Tankless Technical Bulletin

Vertical Venting - Zero Clearance - Demand Pumps

07/08 TKTB-104

Typical 66DV
Vertical Installation

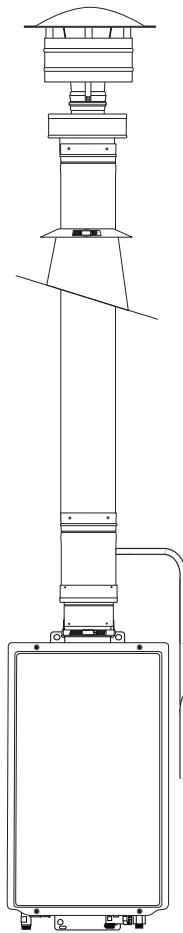
In the past, we required to have a horizontal offset and a form of condensation collector (in-line or condensate tee) for any of our Tankless water heater installations terminated with vertical vent configuration. Effective with this notice Rheem will allow a straight vertical vent run off the top of the water heater provided that a vertical condensate collector, as designed by the appropriate vent manufacturer, is installed as close to the tankless water heater as possible. All other considerations, clearances, and installation requirements as outlined in the Use and Care Manual must be met.
